In response to following issue raised:
1. Overshadowing.
The proposed building envelope results in additional overshadowing of nearby Special Areas (as identified in the North Sydney LEP 2001). Further envelope massing options should be prepared which demonstrate maintenance of solar access to the Miller Street Special Area and the Don Bank Museum Special Area between 10am and 2pm throughout the year, with particular reference to the Equinoxes. The options should indicate any impact on floor space and floor plate areas arising from compliance with Clause 28D (2) (c) of the NSLEP 2001.

The following envelope studies for the site at 177-199 Pacific Highway can be defined through the following keypoints:

Response to DOP letter
(30th August 2010)

Study 6.
Achievable building envelope for no overshadowing to Miller Street Special Area and Don Bank Museum Special Area
Spring Equinox, 23rd September @2pm

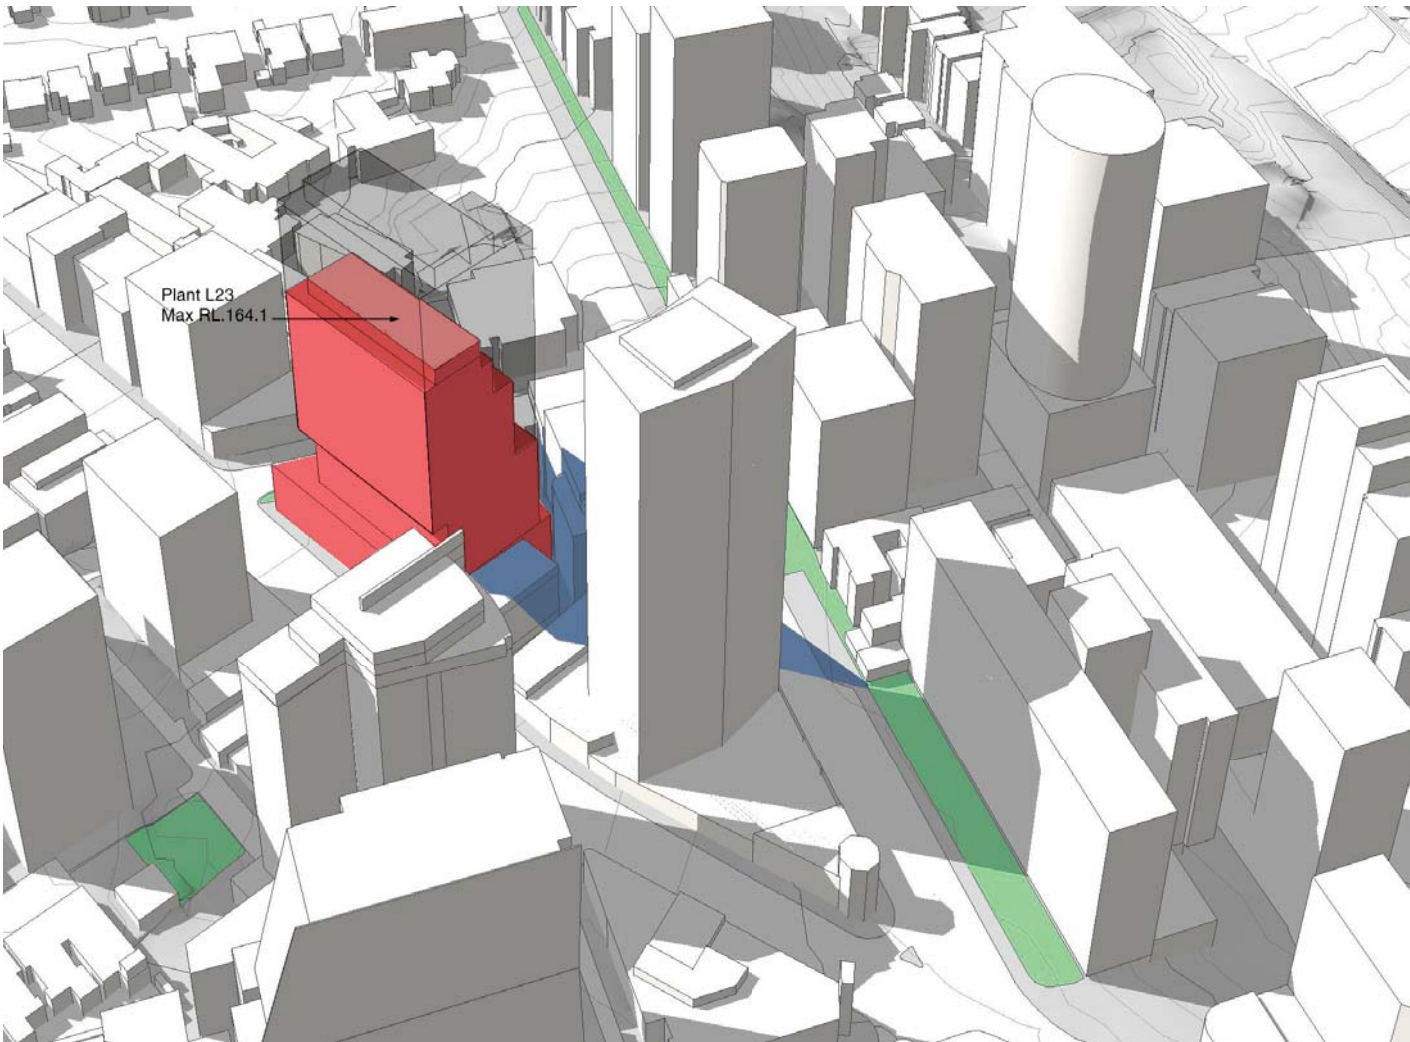
In response to following issue raised:
1. *Overshadowing.*
The proposed building envelope results in additional overshadowing of nearby Special Areas (as identified in the North Sydney LEP 2001). Further envelope massing options should be prepared which demonstrate maintenance of solar access to the Miller Street Special Area and the Don Bank Museum Special Area between 10am and 2pm throughout the year, with particular reference to the Equinoxes. The options should indicate any impact on floor space and floor plate areas arising from compliance with Clause 28D (2) (c) of the NSLEP 2001.

>Max Ht: RL 164.1 (Top of plant Level 23)
>Achievable GFA: 31,490sqm (Loss of 13,280sqm)

Resultant envelope is functional but not economic

Study 6A.
Functional Building Envelope for no overshadowing to Miller Street Special Area and Don Bank Special Area.
Critical Day, 28th August @2pm

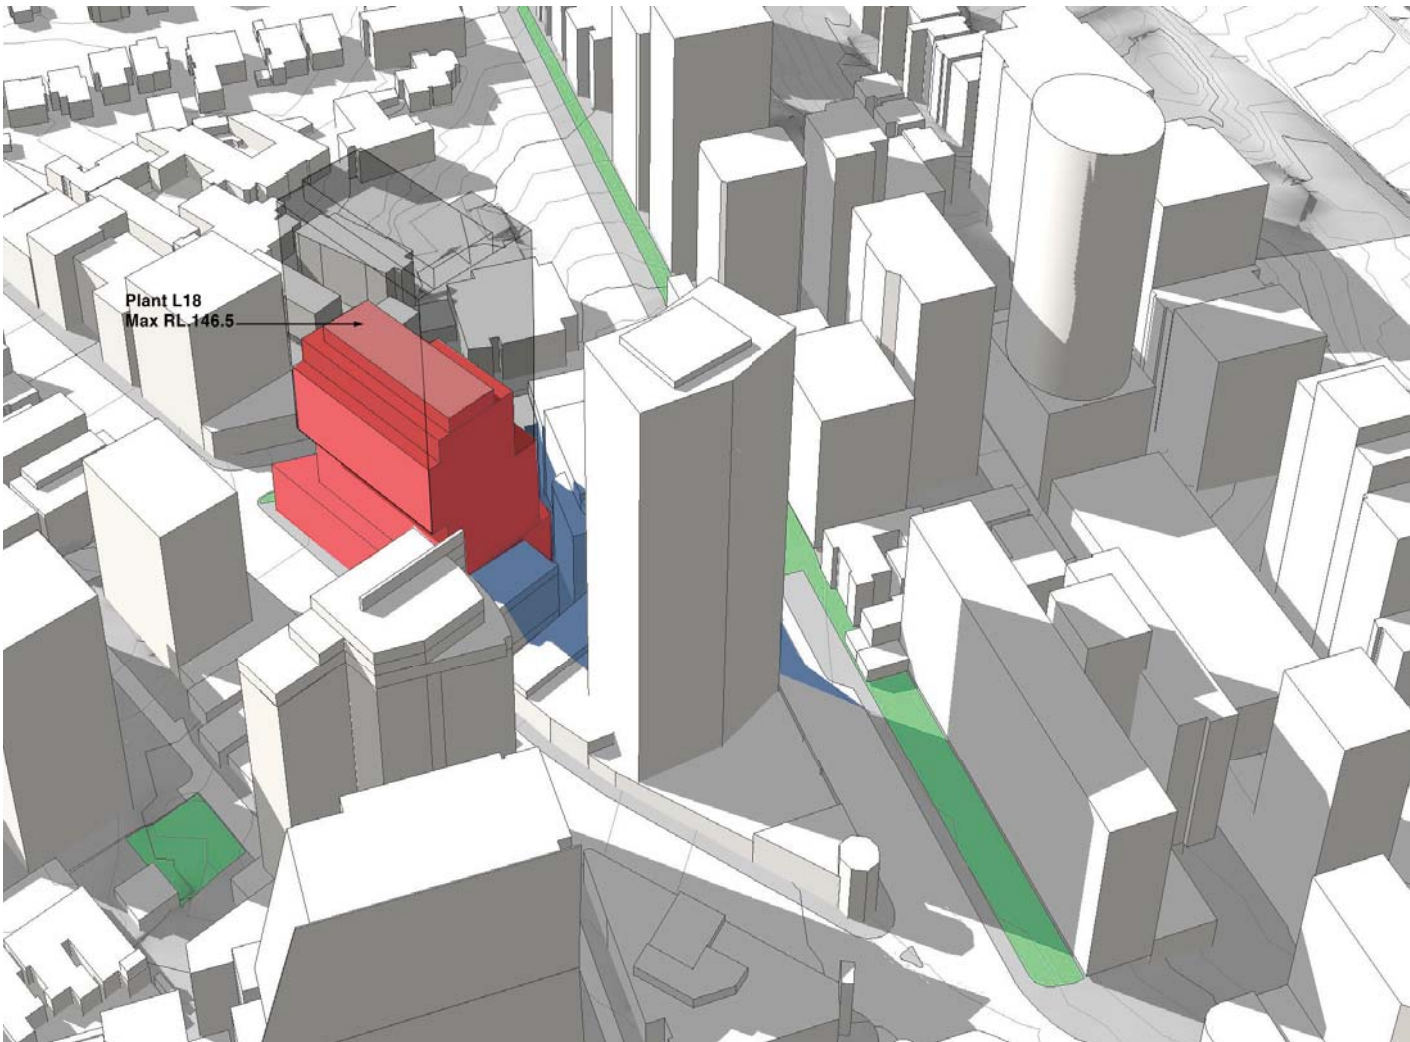
In response to following issue raised:
1. *Overshadowing.*
The proposed building envelope results in additional overshadowing of nearby Special Areas (as identified in the North Sydney LEP 2001). Further envelope massing options should be prepared which demonstrate maintenance of solar access to the Miller Street Special Area and the Don Bank Museum Special Area between 10am and 2pm throughout the year, with particular reference to the Equinoxes. The options should indicate any impact on floor space and floor plate areas arising from compliance with Clause 28D (2) (c) of the NSLEP 2001.

>Max Ht: RL 146.5 (Top of plant Level 18)
>Achievable GFA: 23,235sqm (Loss of 21,535sqm)

Resultant envelope is functional but not economic

West Elevation

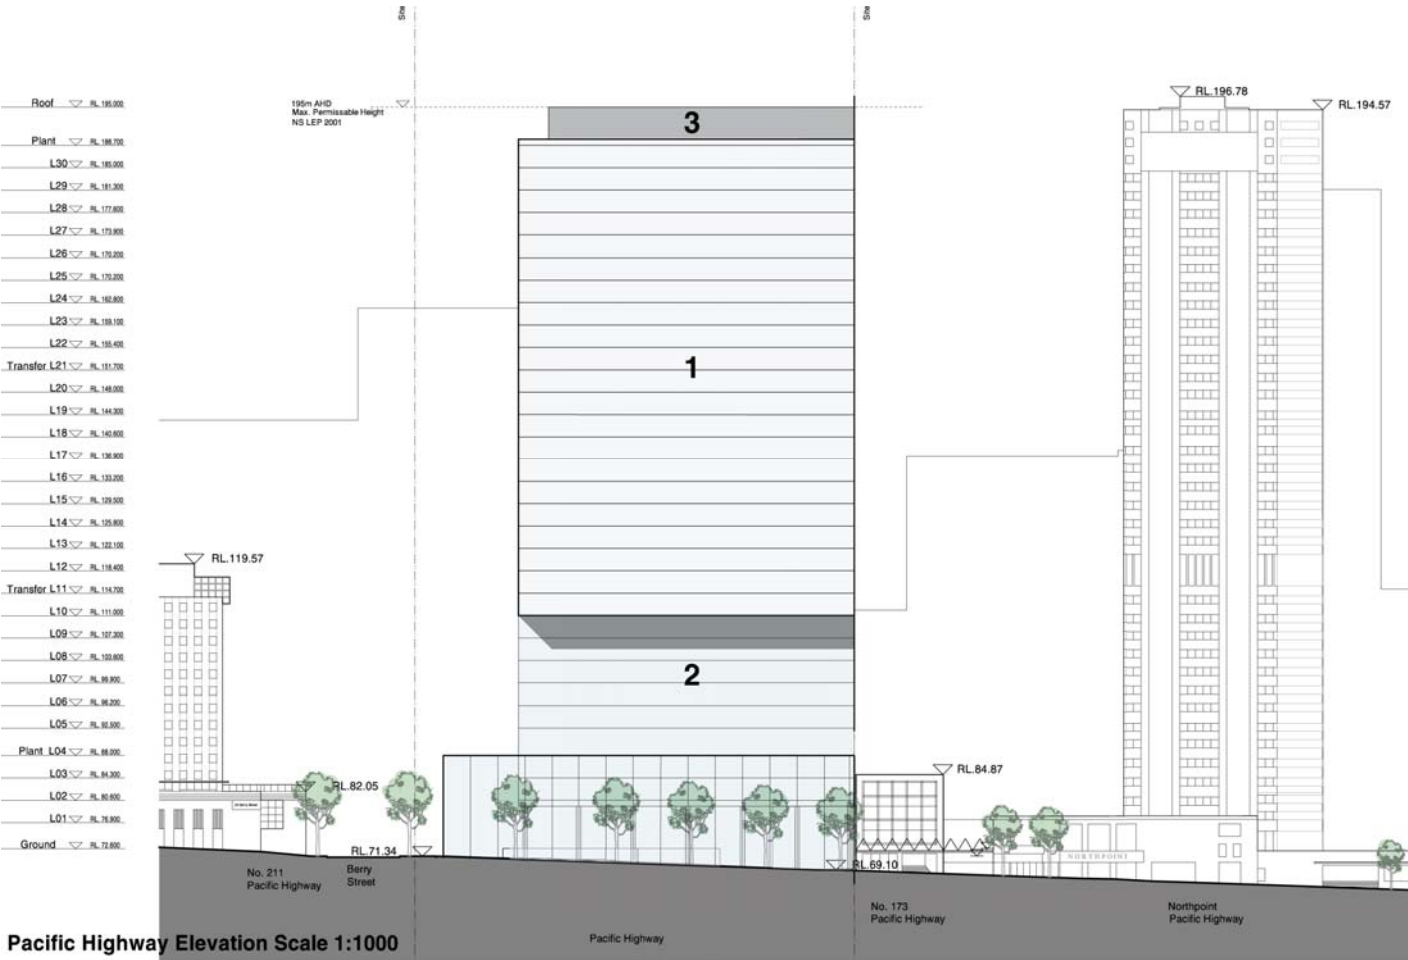
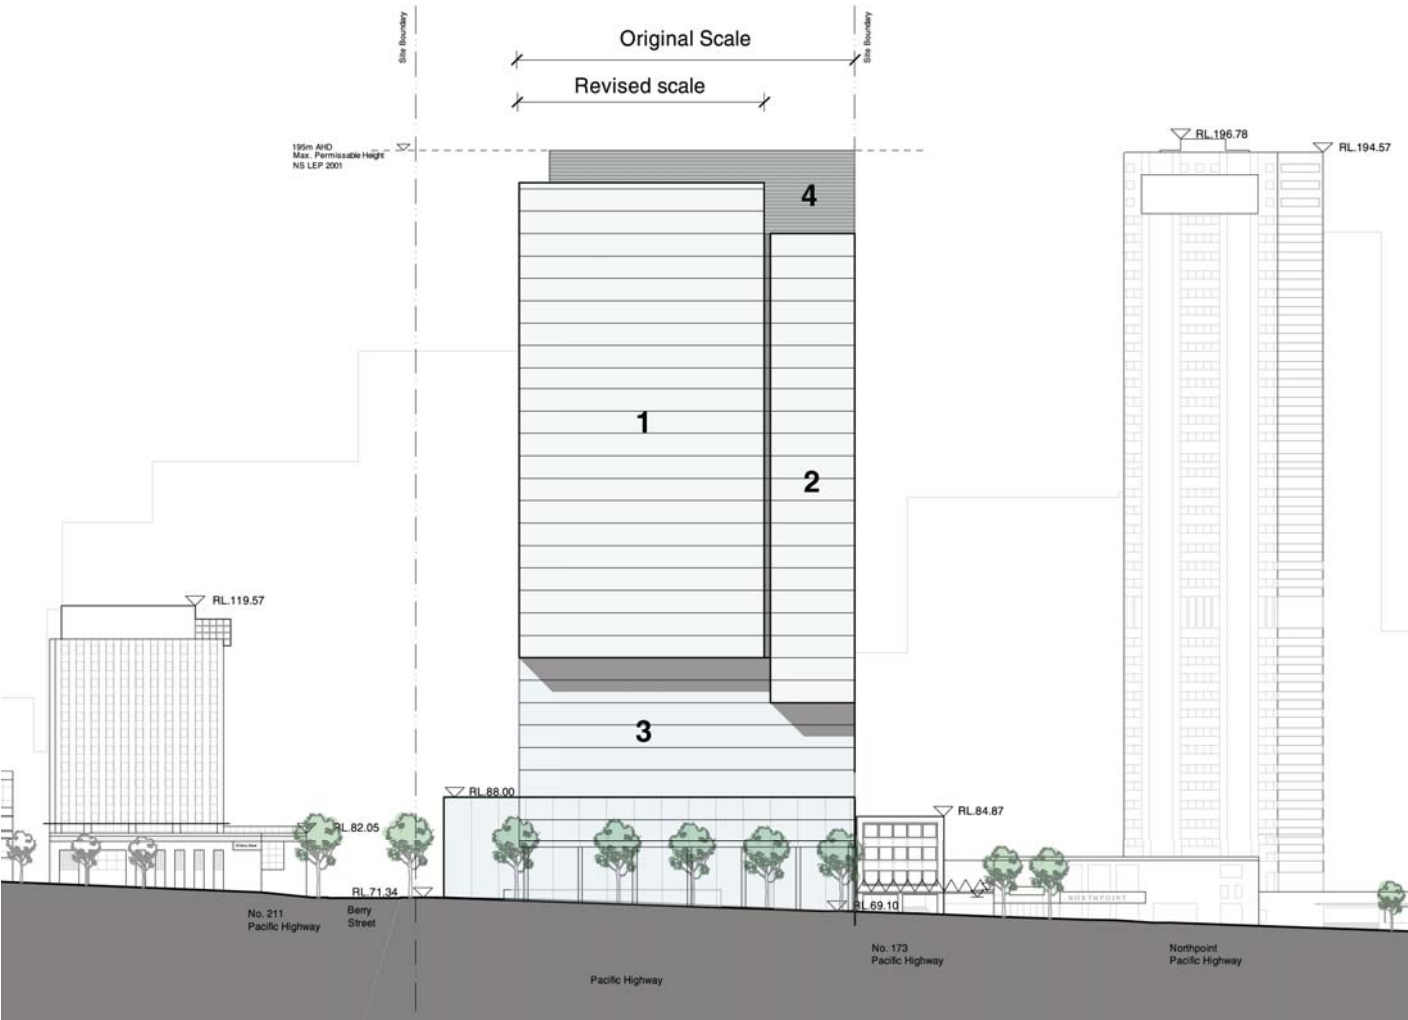
In response to following issue raised:
2. Height, Bulk and Scale.
The envelope of the upper levels of the proposed building will be visually prominent when viewed from the east and west at the edges of the North Sydney City Centre. Further envelope designs for the upper levels of the building should be prepared demonstrating a reduction to bulk and scale, as seen from the east and west, and, the introduction of greater articulation to the upper levels and skyline of the envelope

The proposed envelope is comprised of three distinct articulated mass.

1. Projected volume on Pacific Hwy over the low-rise tower
2. Low-rise tower form setback from Pacific Hwy.
3. Plant area.

The proposed envelope could be further articulated to reduce bulk and scale. This could be achieved in the following:

1. Reduced width of the projected volume on Pacific Hwy to create a more slender vertical expression of the tower form.
2. Introduce an additional element of articulation e.g slipped form, to further 'break-down' the mass of the envelope.
3. Low-rise tower form setback from Pacific Hwy.
4. Plant area and upper level setback.

East Elevation

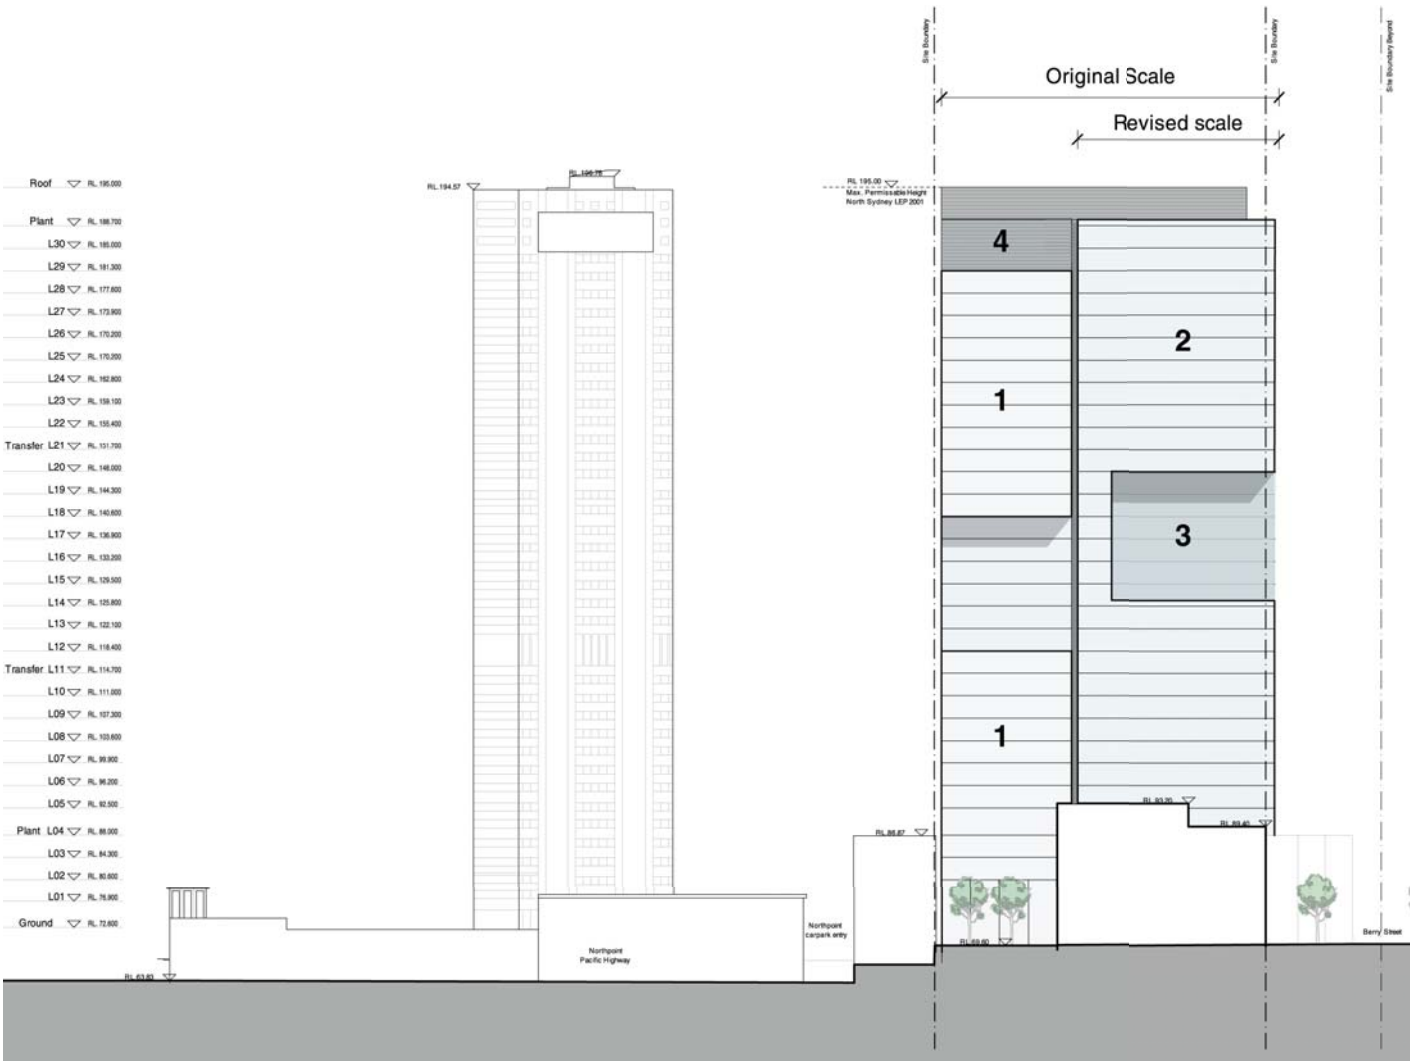
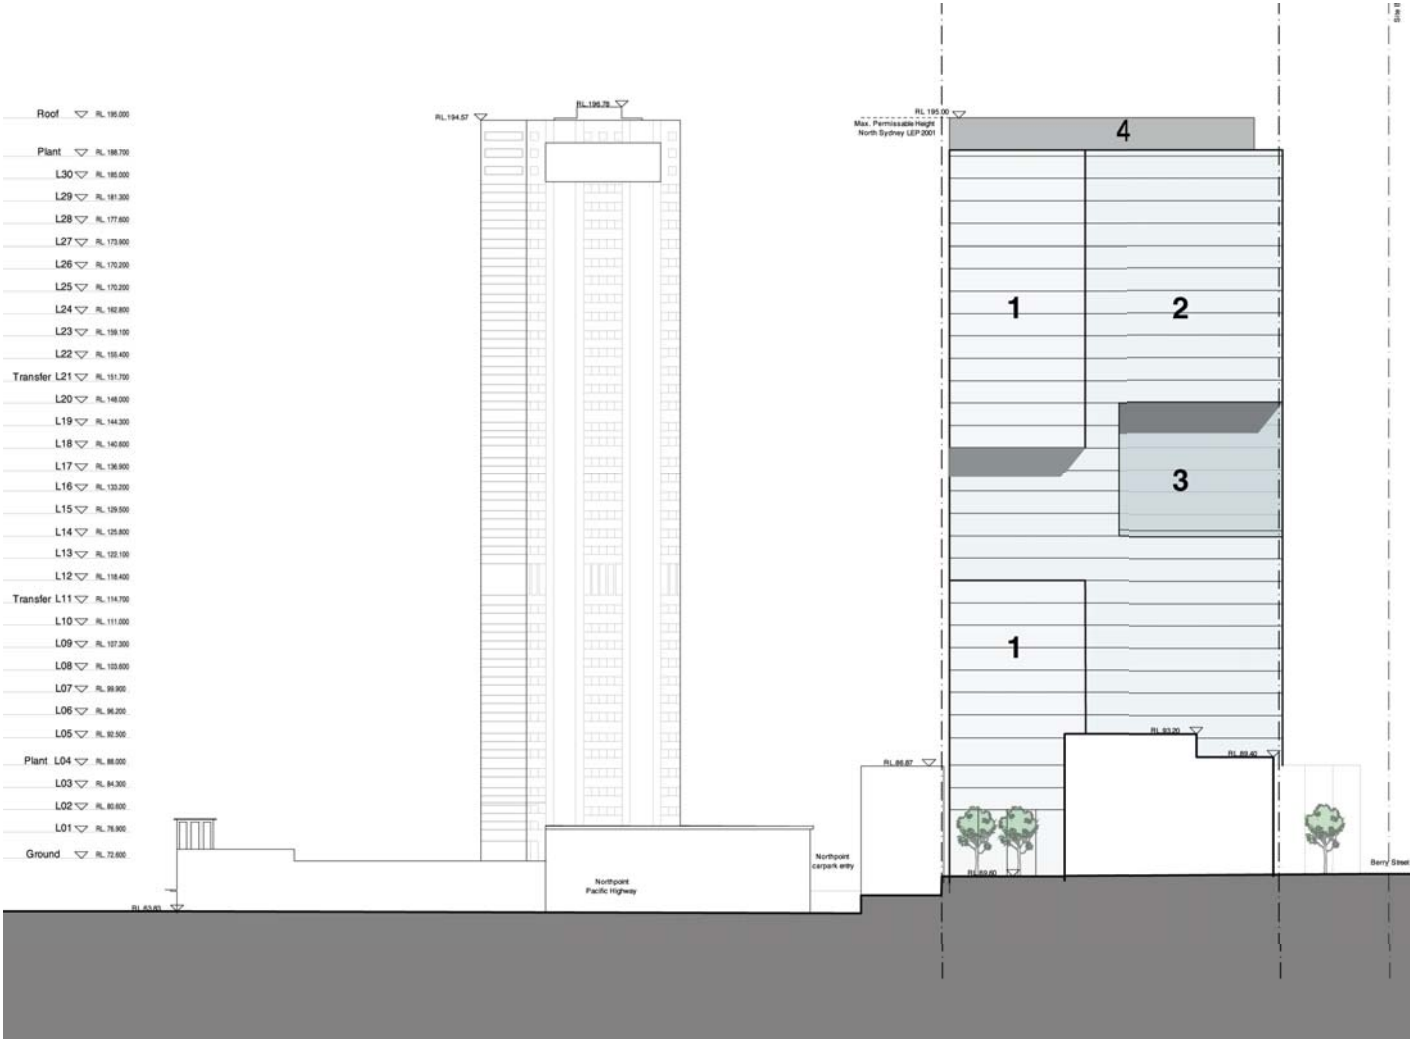
In response to following issue raised:
2. Height, Bulk and Scale.
The envelope of the upper levels of the proposed building will be visually prominent when viewed from the east and west at the edges of the North Sydney City Centre. Further envelope designs for the upper levels of the building should be prepared demonstrating a reduction to bulk and scale, as seen from the east and west, and, the introduction of greater articulation to the upper levels and skyline of the envelope

The proposed envelope is comprised of series articulated masses which have been derived from a combination of site geometry and also by avoiding overshadowing at the Winter Solstice.

1. Projected volumes to rear of site
2. General tower form.
3. Extracted volume set back to avoid overshadowing of Miller St Special Area.
4. Plant area.

The proposed envelope could be further articulated to reduce bulk and scale. This could be achieved in the following:

1. Slipped form expression to reduce the bulk at the top of the building.
2. Introduce additional vertical articulation to create a more slender tower form.
3. Extracted volume set back to avoid overshadowing of Miller St Special Area.
4. Plant area and upper level facade articulation.
